SH1/SH29 Intersection Upgrade Project – Response to further information request from Matamata-Piako and South Waikato District Council

South Waikato District Council: Reference ID RM210072

Matamata-Piako District Council: Reference ID 105.2021.12388

STATE HIGHWAY 1 AND STATE HIGHWAY 29 INTERSECTION UPGRADE

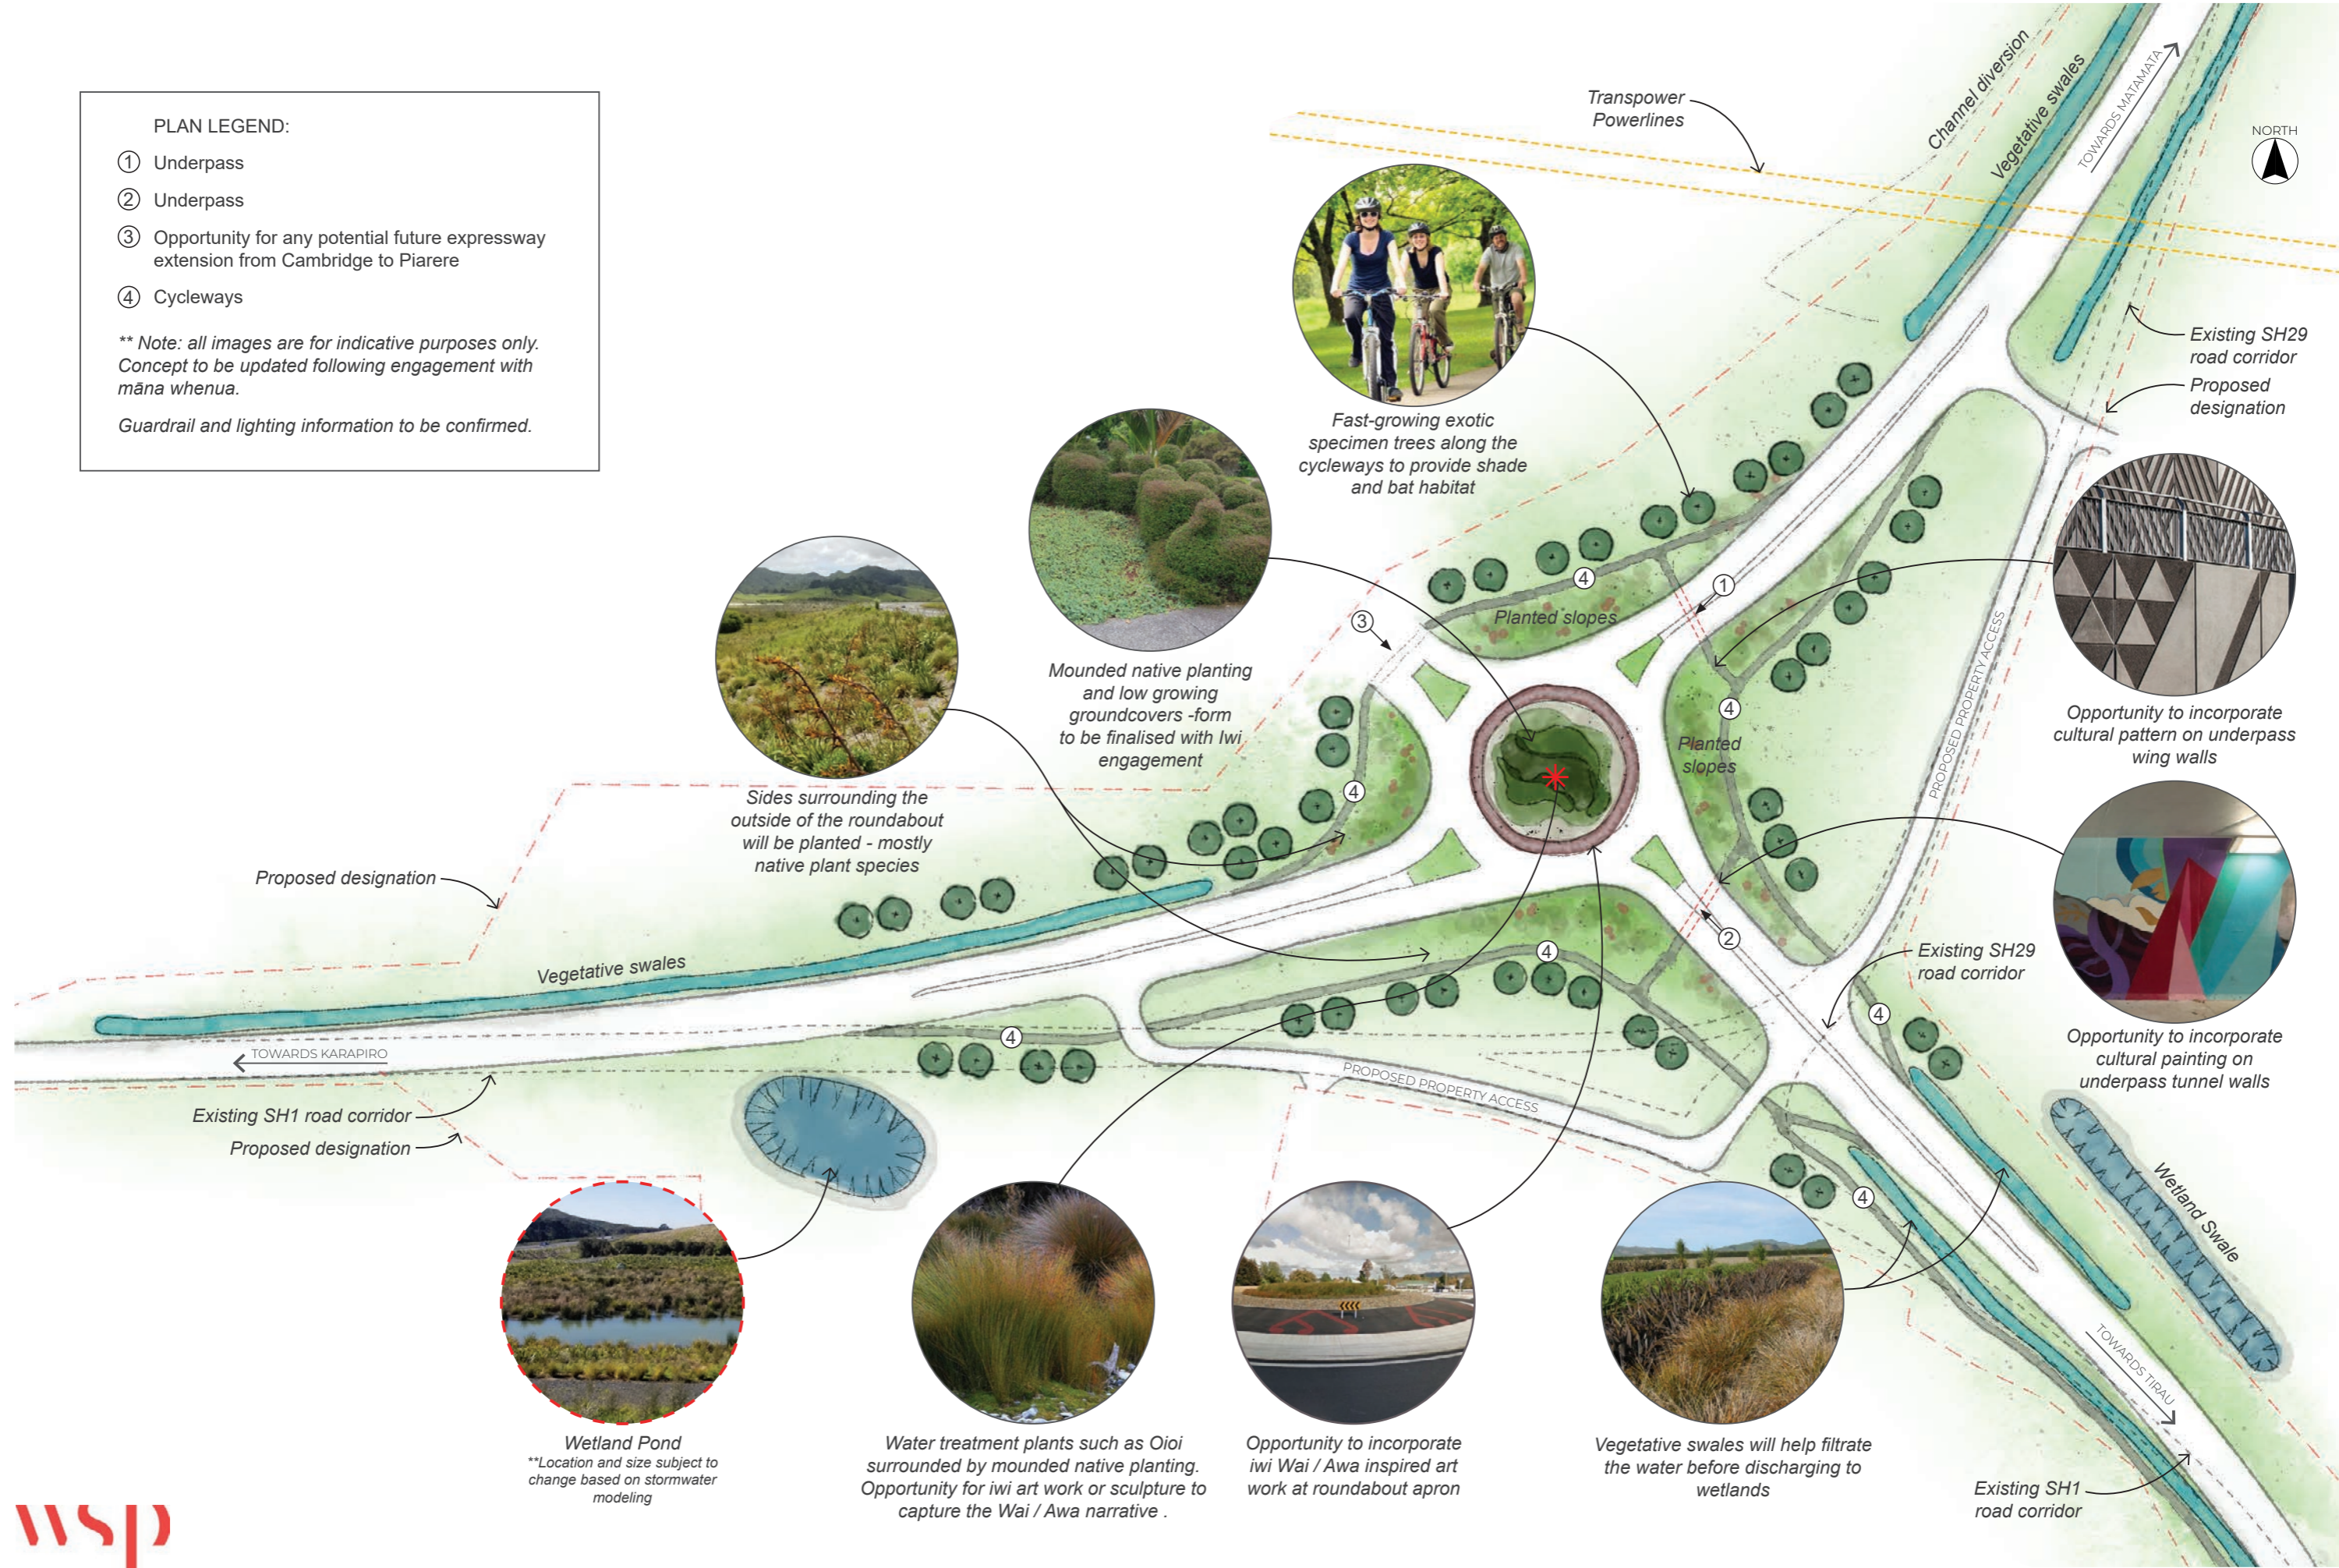
Please provide a methodology statement which confirms the accuracy of the photomontage image from Viewpoint 1 which informs the landscape assessment; and provide any required update to this image in relation to illustrating the following aspects of the proposal:

- Existing trees that are proposed for removal;*
- The scale of any new trees that have been modelled and their estimated age in the image;*
- Deletion of any existing powerlines and power poles that are to be removed;*
- Addition of new lighting standards (indicative only if not yet designed); and*
- Confirmation that the modelled height of the road surface is accurate.*

Please also provide 50mm-lens single-frame images of the area of focus within the existing and proposed views, with these images being presented to the full scale of an A3-sized page (landscape orientation).

Attachment A to this letter is the requested updated landscape visuals. This document provides the methodology statement for the visual simulations. It also includes an updated photomontage image from Viewpoint 1 taking into account matters (a) to (d) above. In relation to matter (e), Waka Kotahi confirms that the modelled height of the road surface is accurate.

The updated landscape visuals in **Attachment A** to this letter provides the requested images.
